Access Compliance Report

Public Rights-of-Way

(Curb Ramps)

Intersection ID: 14579	Main Street: BASIN_ST	Cross Street: S_TRYON_ST	Location: W
ADA ID: 0240D8EB1315	Ramp Type: PerpDiag	Initial Pass/Fail: Fail	Overall Compliance: No
Severity Score: 17.5			
Codes/Mitigation Info/Possible Solution		Field Measurements/Component Compliance

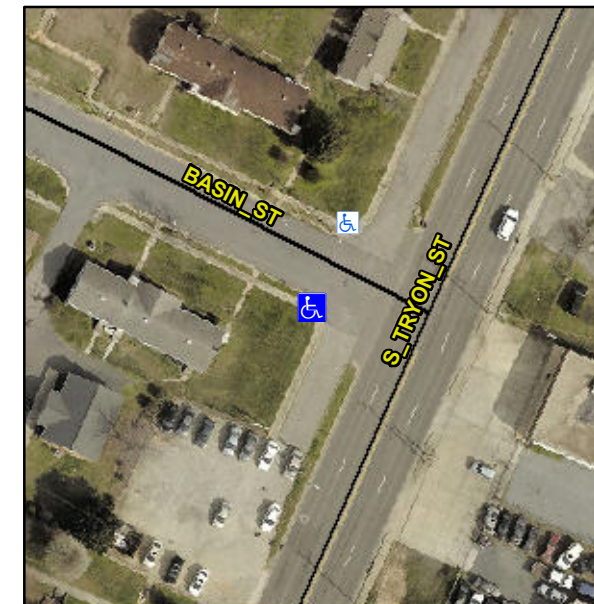
Compliance	Description	Data	Compliance	Description	Data
N/A	Ramp Length (in)	57.0	Yes	Ramp Slope (%)	6.9
No	Ramp Width (in)	33.0	Yes	Ramp XSlope (%)	0.8
N/A	Flare Type LT	N/A	N/A	Flare Type RT	N/A
N/A	Flare Slope LT (%)	N/A	N/A	Flare Slope RT (%)	N/A
N/A	Flare Traversable LT?	N/A	N/A	Flare Traversable RT?	N/A
N/A	Landing Length (in)	N/A	N/A	DWS Provided?	N/A
N/A	Landing Width (in)	N/A	N/A	DWS Contrast?	N/A
N/A	Landing Slope (%)	N/A	N/A	DWS Length (in)	N/A
N/A	Landing X Slope (%)	N/A	N/A	DWS Full Width?	N/A
N/A	Landing Curb? (Y/N)	N/A	N/A	DWS Offset (in)	N/A
N/A	Shared Landing?	N/A			
N/A	Gutter Ponding?	N/A	N/A	Gutter Slope (%)	N/A
N/A	Gutter Lip Ht (in)	N/A	N/A	Gutter X Slope (%)	N/A
N/A	Painted X Walk1?	No	N/A	Painted X Walk2?	No
	X Walk 1 Direction	To SE		X Walk 2 Direction	To NE
N/A	X Walk 1 Width (in)	N/A	N/A	X Walk 2 Width (in)	N/A
	X Walk 1 Slope (%)	0.9		X Walk 2 Slope (%)	9.0
	X Walk 1 X Slope (%)	3.9		X Walk 2 X Slope (%)	0.8

N/A	Ramp inside XWalk1?	N/A	N/A	Ramp inside XWalk2?	N/A
	Road Slope (%)	0.7	N/A	Clear Space?	N/A
	Road X Slope (%)	1.9	N/A	Clear Space to XWalk (in)	N/A
N/A	Any Obstructions?	N/A	N/A	Storm Grate/Utility Hazard?	N/A
	Obstruction Type			Storm Grate/Utility Type	
		N/A			N/A
			Yes	Surface Condition? (G/P)	Good

Remove & Replace Curb Ramp With Two New Directional Ramps or Equivalent.
